Little Thompson Watershed Coalition

CDBG-DR WATERSHED RESILIENCE & NRCS EMERGENCY WATERSHED PROTECTION
IMPLEMENTATION PROJECT: NORTH 83rd STREET

QUESTIONS (From the Pre-Bid Meeting, Site Visit and Follow-up)	ANSWERS
Bid Questions:	
Will LTWC select the lowest bidder as the contractor? –	LTWC will select the most qualified bidder per the criteria set out in the RFP.
Should the bidders just bid the total amount available for the project?	LTWC will select the most qualified bidder per the criteria set out in the RFP.
Will there be a list of subcontractors sent out so contractors can contact possible subcontractors?	Yes, LTWC will provide a list of the sub-contractors that were present at the pre-bid meeting.
Will LTWC make AutoCAD file available for bidders?	No, the AutoCAD file will only be made available to the selected contractor.
Will we make property owner’s contact information available to the bidders?	No, the property owner information will only be made available to the selected contractor.
Contract Questions:	
Are there penalties for being late on this project?	The funds expire in the end of June 2017, if the project is not complete by then the contractor can’t be paid.

Pla

**LITTLE THOMPSON ABOVE N 83RD ST
 SITE PLAN**

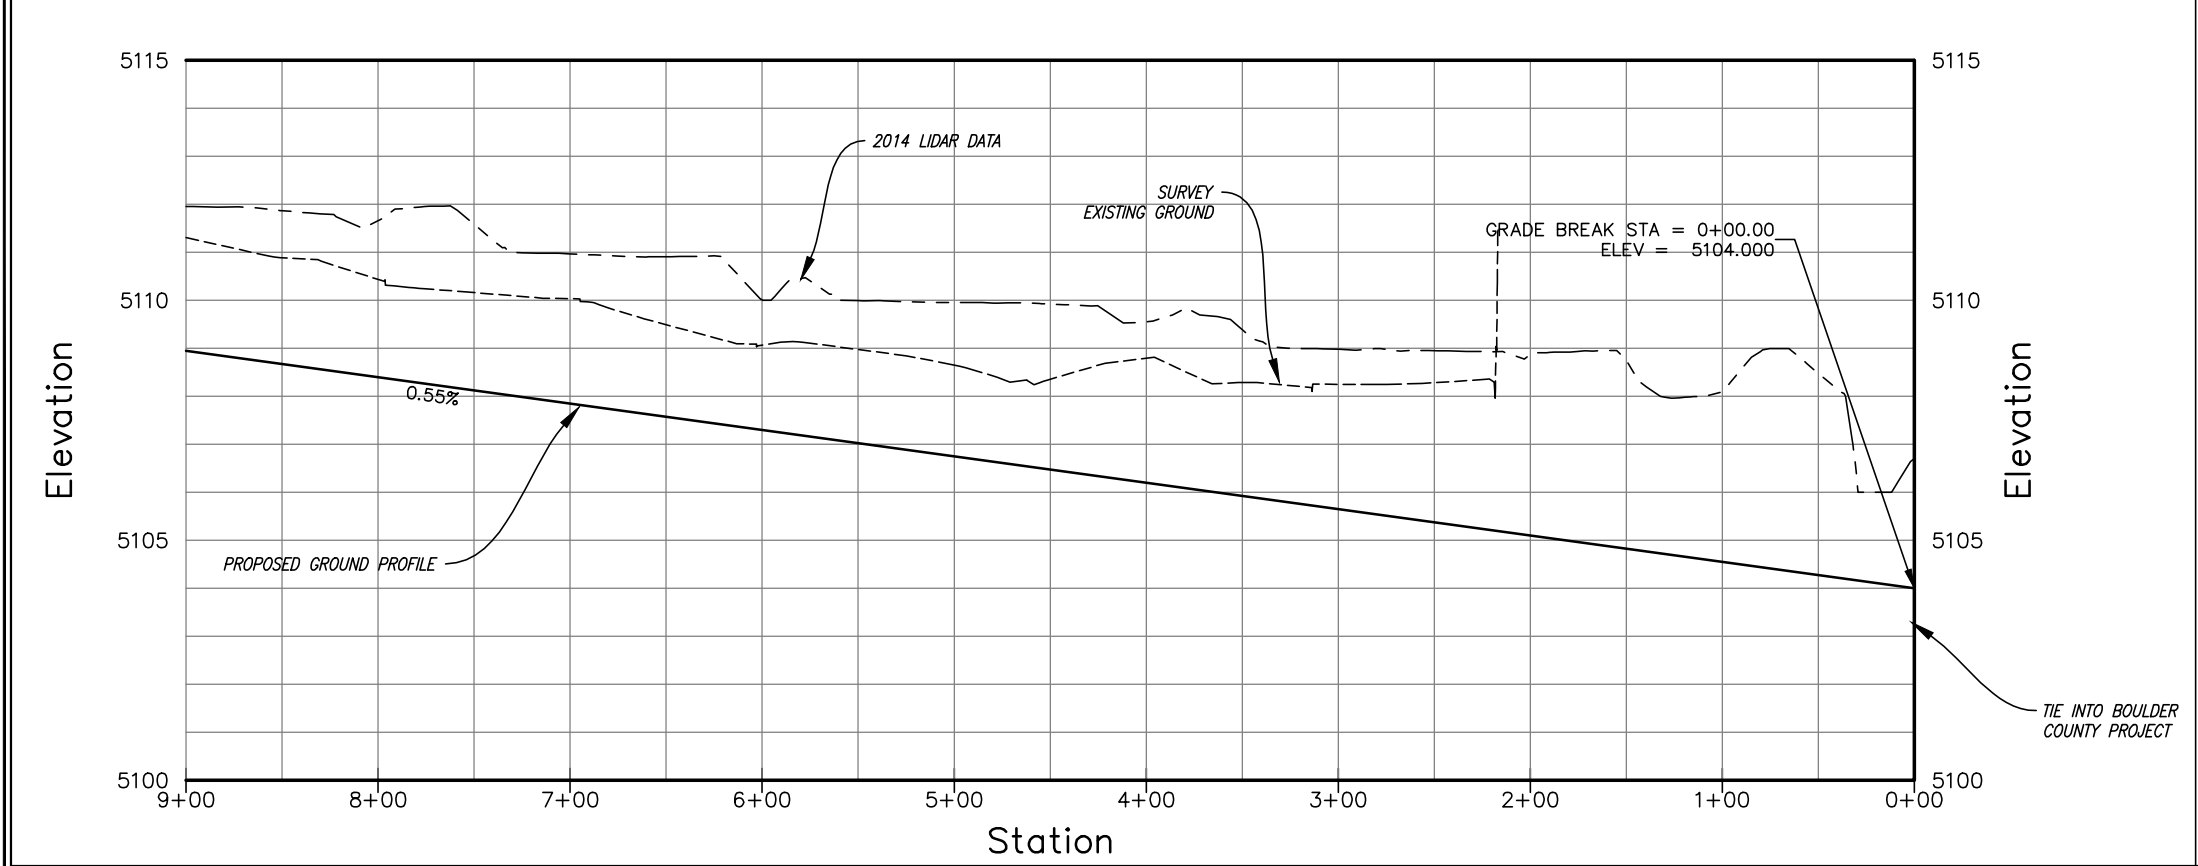
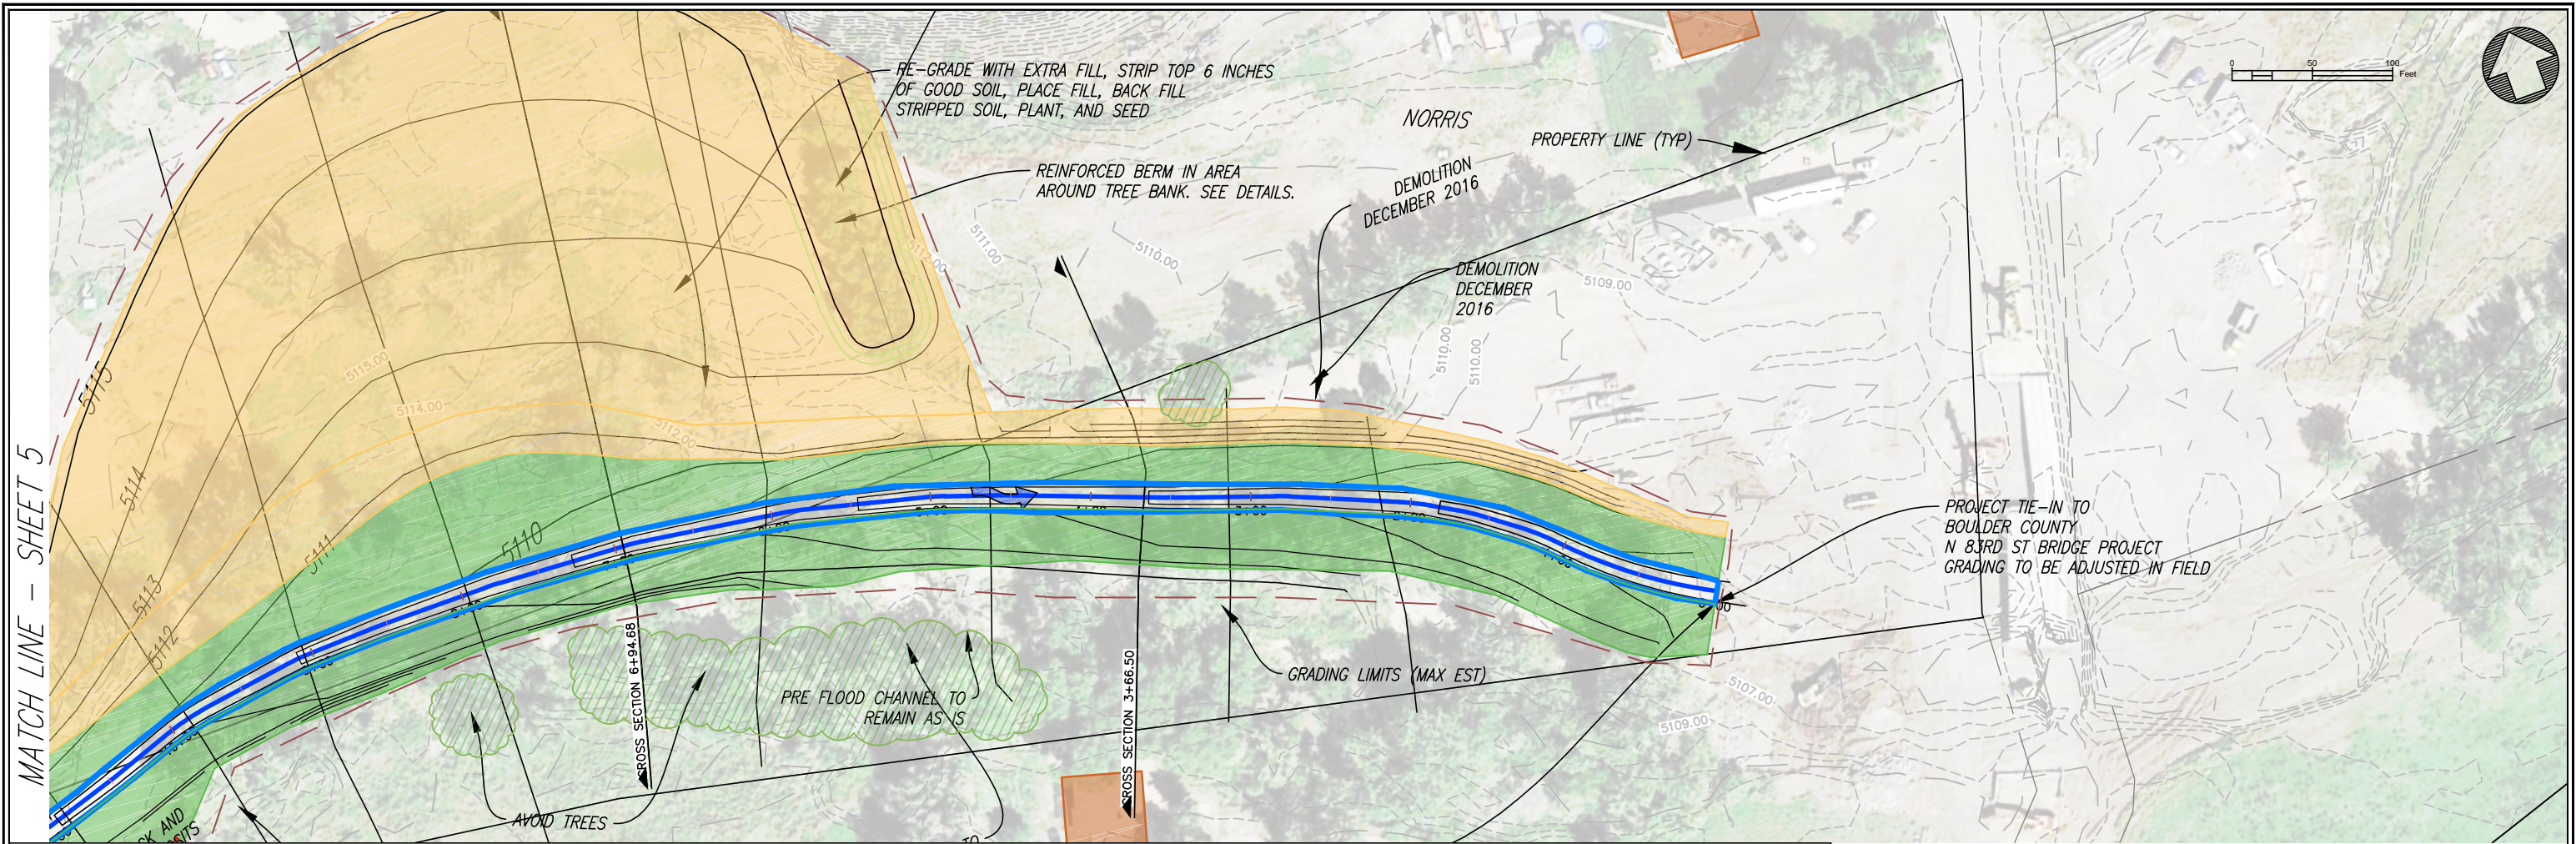
Sheet ID	Sheet Title	Revision Description
01	Cover Sheet	None
02	General Notes and Legend	Minor updates to the legend
03	Control Sheet	None
04	Site Plan	Planting zone and bank treatment updates
05-06	Grading Plan and Profile	Removed soil lifts treatment, reduced berm height
07	Profile and Typical Section	None
08-09	Cross Sections	Updated bank treatment designations
10	Riffle Detail 1	None
11	Riffle Detail 2	None
12	Detail Sheet	Removed soil lift detail
13-14	Planting Plan	Zone 4 is now Zone 3 seeding only, updated bank treatments
15	Planting Sheet Detail	None
16	Planting Zone Tables	Removed Zone 4 table, updated Zone 2 and 3 tables, updated bank treatment table

REVISION	DESCRIPTION	BY	DATE
(R-1)	BANK TREATMENTS & PLANTING	SLH	12/29/16
(R-2)			
(R-3)			
(R-4)			
(R-5)
